STAFF RECOMMENDATION
706 Fatherland Street
August 19, 2020

Application: New Construction – Addition; Alterations
District: Edgefield Historic Preservation Zoning Overlay
Council District: 06
Base Zoning: R8
Map and Parcel Number: 08216024200
Applicant: Rob Cowles
Project Lead: Melissa Sajid, Melissa.sajid@nashville.gov

Description of Project: Application is to construct a rear addition and to retain front porch posts that were replaced without a preservation permit.

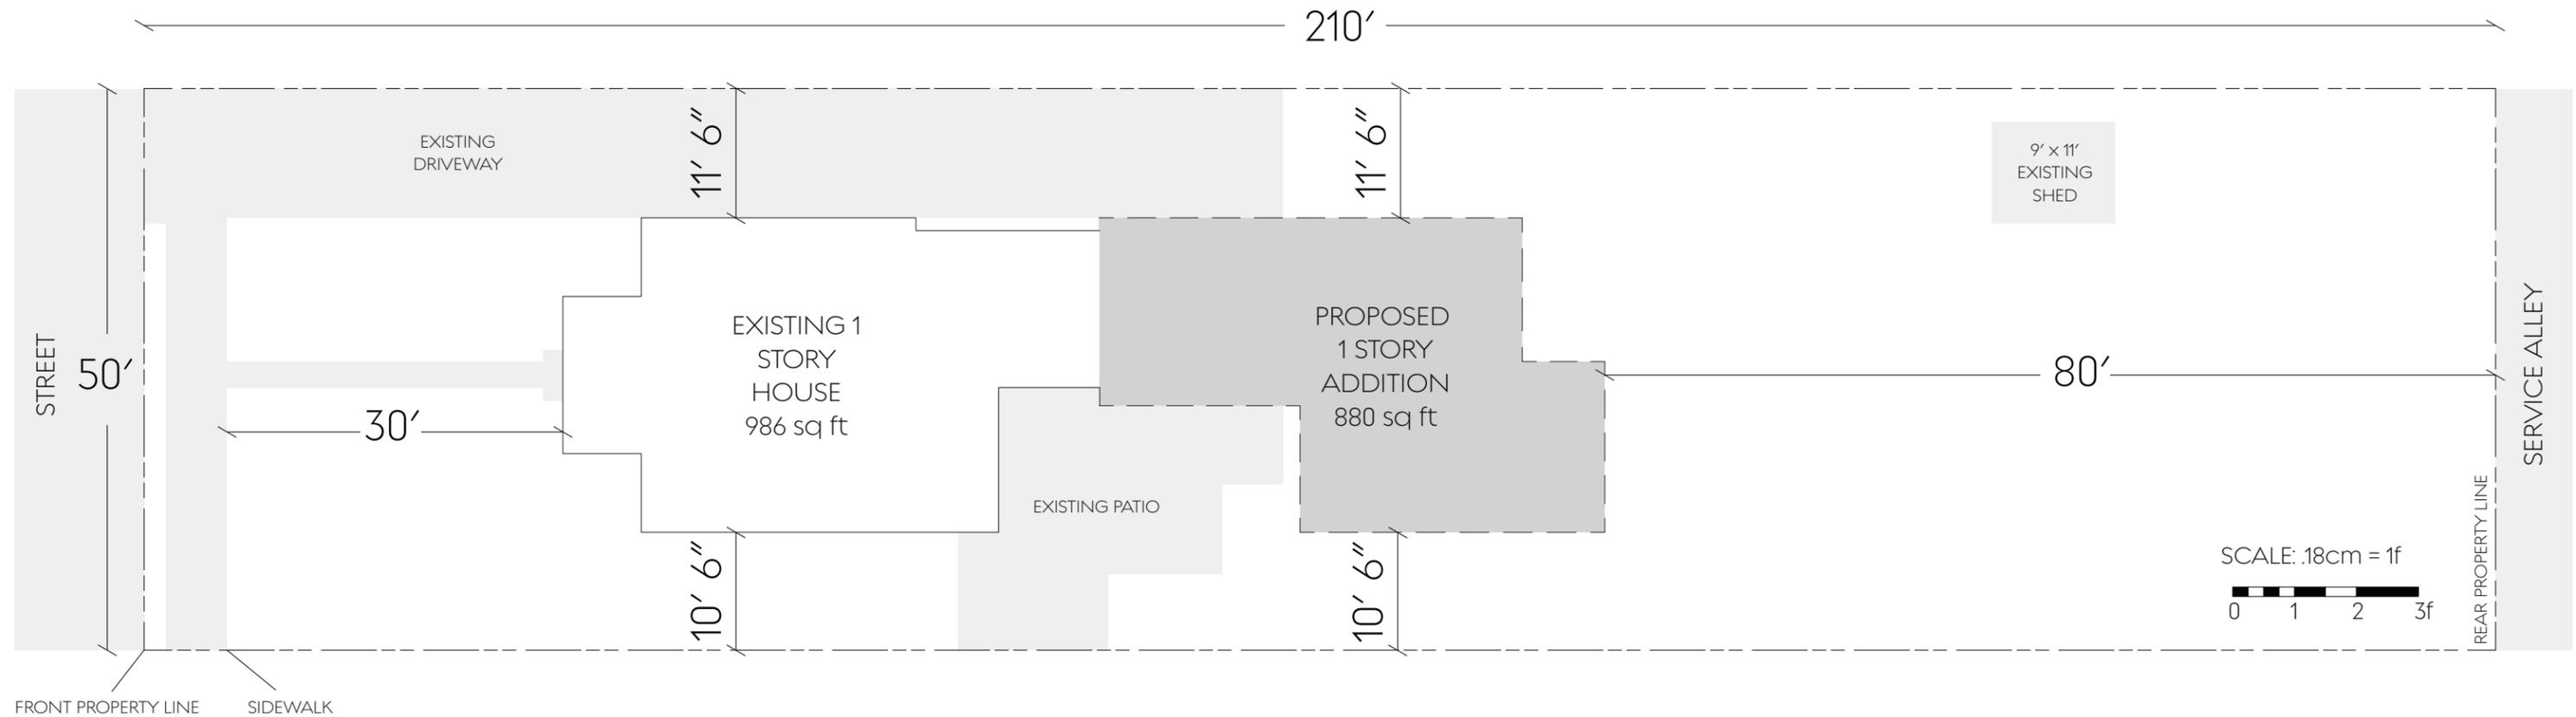
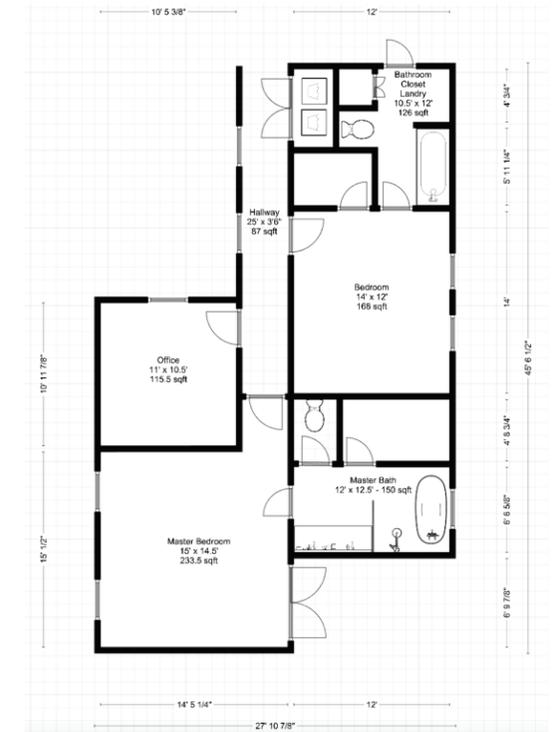
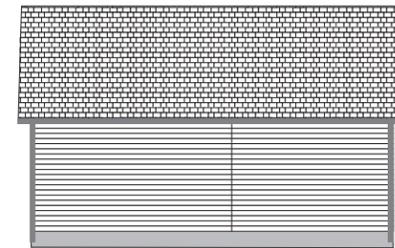
Alterations: The front porch posts were replaced (Figure 1) prior to obtaining a preservation permit. The previous porch posts were a metal ornamental design that was not original to the house (Figure 3) on brick pedestals that are likely original. The 1969 Property Assessor's photo appears to show tapered wood posts (Figure 4). While replacing the metal posts would have been appropriate since they were not original, staff finds that an appropriate replacement would be a simple design similar to those seen in the 1969 photo rather than the more modern design that was installed (Figure 1).

When the posts were replaced, the brick piers were also painted white (Figure 1). Painting of brick that was previously unpainted is inappropriate and does not meet the design guidelines. However, this is a frame house and the brick piers are the only brick found on the house. Since it is such a small part of the house, staff finds that it may be appropriate for the piers to remain painted as long as the paint color is closer to the original color of the brick.

With the condition that the front porch posts shall be a simple design and the brick piers shall be repainted a color closer to the original brick color, staff finds that the alterations can meet Sections II.B.2.a and II.B.3.c.4 of the design guidelines.

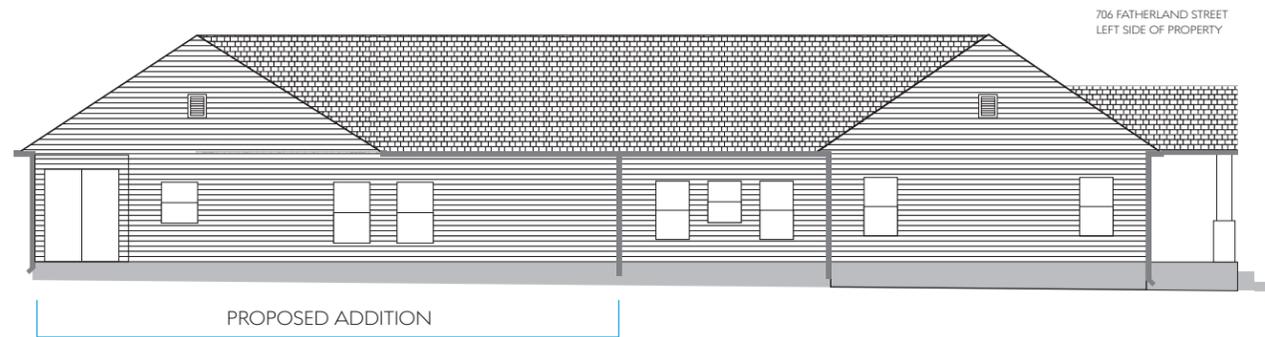
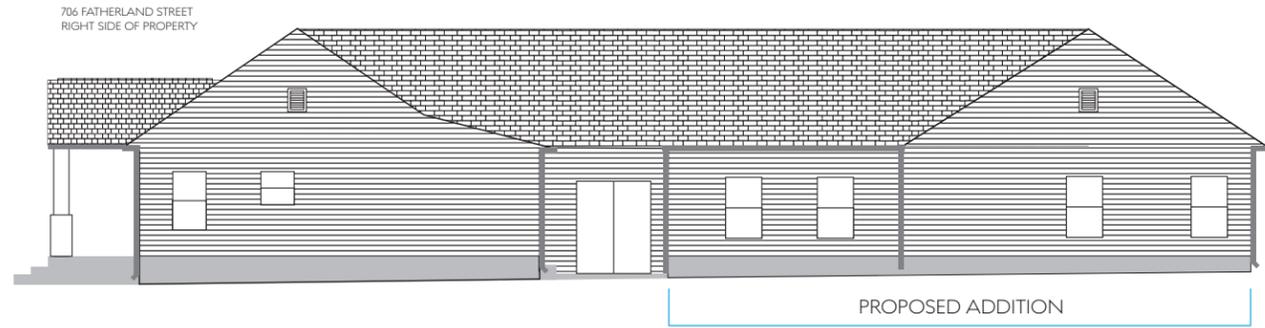
While none of the materials are indicated on the plans, the addition appears to be clad in siding to match the existing house. The plans do not show the required four-inch (4”) casings around all windows and doors or four-inch (4”) corner boards at the face of each exposed corner. With the conditions that staff approve all materials prior to purchase and installation, that four-inch (4”) casings are required around all windows and doors, and that four-inch (4”) corner boards are required at the face of each exposed corner, staff finds that the project meets Section III.B.2.g.

Proportion and Rhythm of Openings: No changes to the window and door openings on the existing house were indicated on the plans. The windows on the proposed addition are all generally twice as tall as they are wide, thereby meeting the historic proportions of openings. There are no large expanses of wall space without a window or door opening. Staff finds the project’s proportion and rhythm of openings to meet Section III.B.2.f.

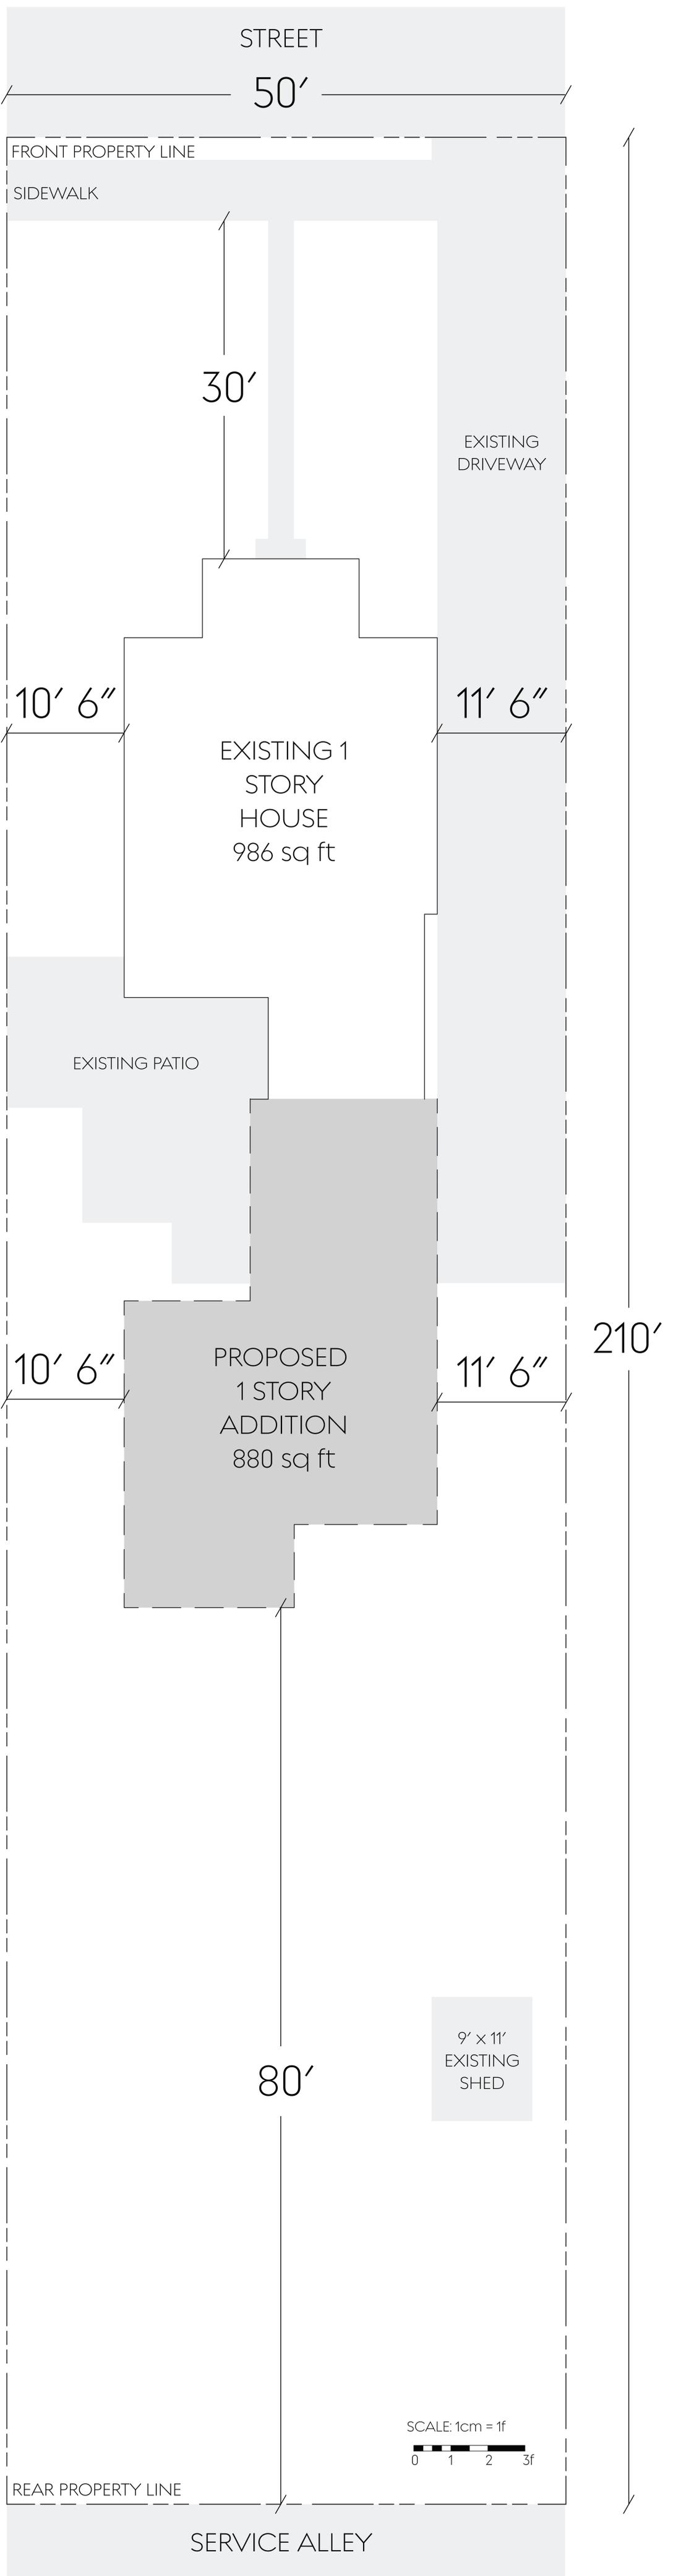
Appurtenances & Utilities: No changes to the site’s appurtenances were indicated on the drawings. The location of the HVAC and other utilities was also not noted. Staff asks that the HVAC be located on the rear façade, or on a side façade beyond the midpoint of the house. The project meets Section III.B.2. i.

706 FATHERLAND STREET
LEFT SIDE OF PROPERTY

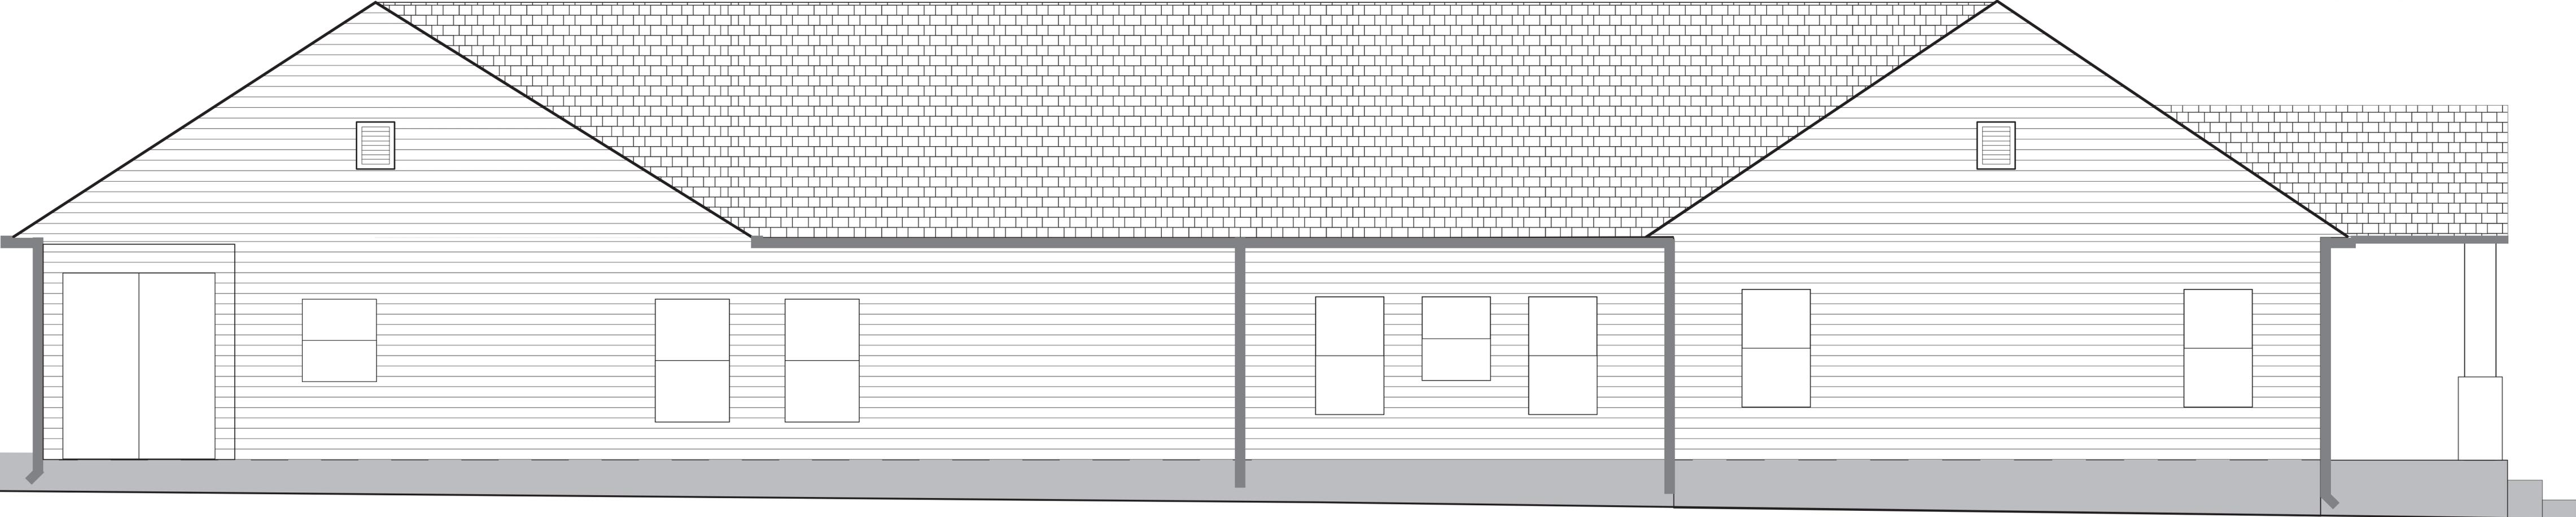
Location & Removability: The location of the addition at the rear of the existing building is in accordance with the design guidelines. The proposed addition is not inset which is appropriate since it does not tie directly into the historic house. The addition matches the width of the historic house where it ties into the existing addition on the left-side, which is approximately sixteen feet (16') behind the rear corner of the historic house. On the right-side, the new addition comes back out to match the width of the historic house approximately twenty-seven feet (27') behind the rear corner of the historic house.

706 FATHERLAND STREET
RIGHT SIDE OF PROPERTY

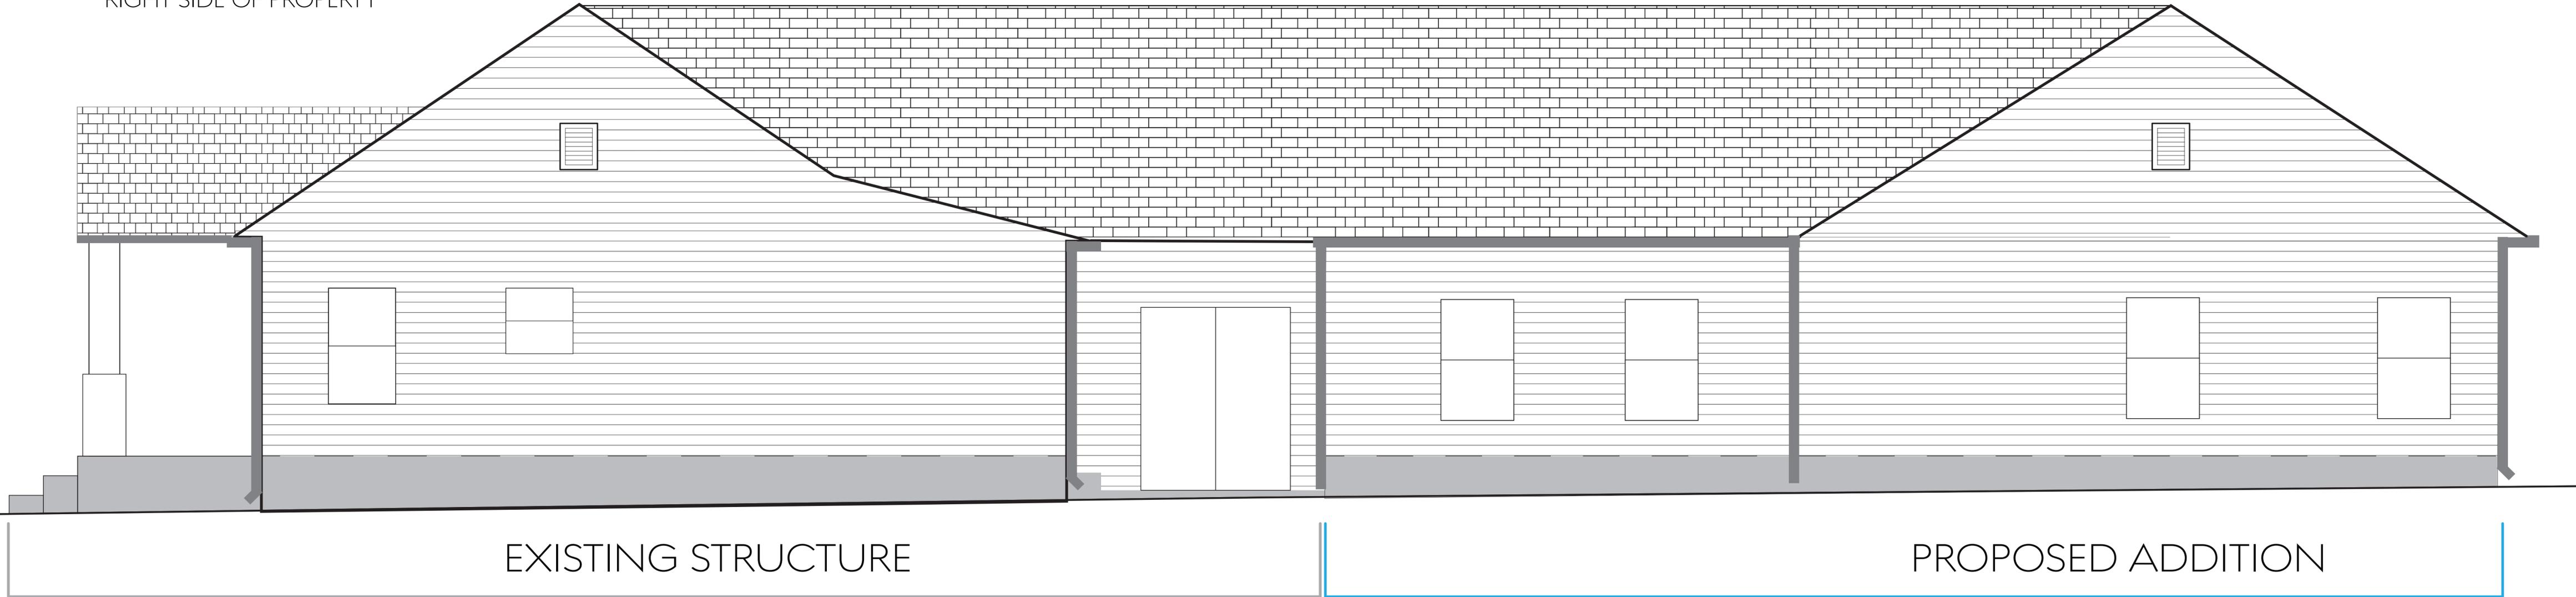
The addition ties into an existing rear addition (Figure 2). The footprint of the existing rear addition will not change, but the shed roof form is to be altered to a gable to create a cross-gable roof form for the addition. Altering the shed roof form of the existing addition allows for the new addition to tie in more cohesively to the historic house and prevents the appearance of a house behind a house.
